Our Case Number: ACP-323849-25

Re: The proposed development is for a mixed use development that seeks the regeneration and adaptive reuse of a strategic brownfield site, as part of the Limerick City and County Council 'World Class Waterfront revitalisation and transformation project' 'Cleeves Riverside Quarter' in the townland of Farranshone More in Limerick City.

Formal Observation / Objection

Re: Proposed Development — Cleeves Riverside Quarter / Cleeves Riverside Campus

Fig 2. Interior photos of Fernbank house architecture

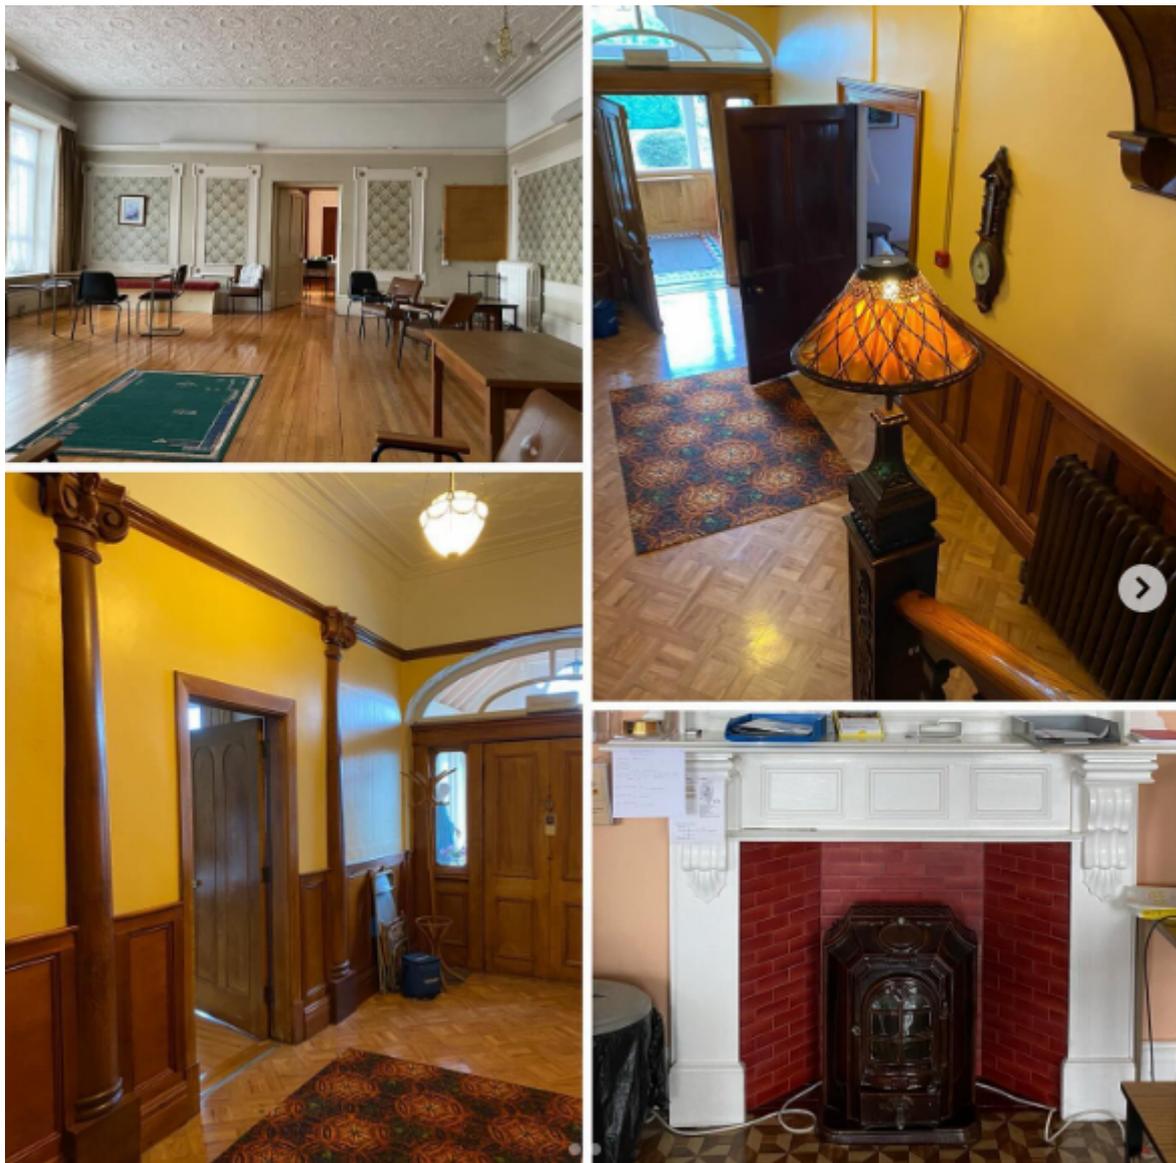
E. Local Heritage: Failure to Preserve and Integrate Fernbank House

- **Harm to the setting of a building that should be listed as a protected structure:** The proposed development requires the destruction of Fernbank House, which is an architectural gem.

- Fernbank House, a part of the Salesians Secondary school site, not mentioned in the plans of the local authority, is an important local heritage asset. The scale, design, and materials of the proposed development are fundamentally out of character with the historical setting of the building and will result in a significant and irreversible loss of its special architectural and historic interest. The loss of a key historical view from the building and its grounds is a serious concern.

- **In the application no mention of this building is made.** It is to be demolished as per the plans. However this was one of the first buildings on the north side of the river bank at Limerick from 1800-onwards.

- Local Authority to list this building as a protected structure in alignment with local and national guidelines and as has been called for by locals and local historians alike for years, since it's purchase.
- Provide a Conservation Report and structural appraisal
- Provide a Structural appraisal and reuse proposal
- Provide adaptive reuse proposal
- Design to respond to and meaningfully integrate Fernbank house into the proposed masterplan
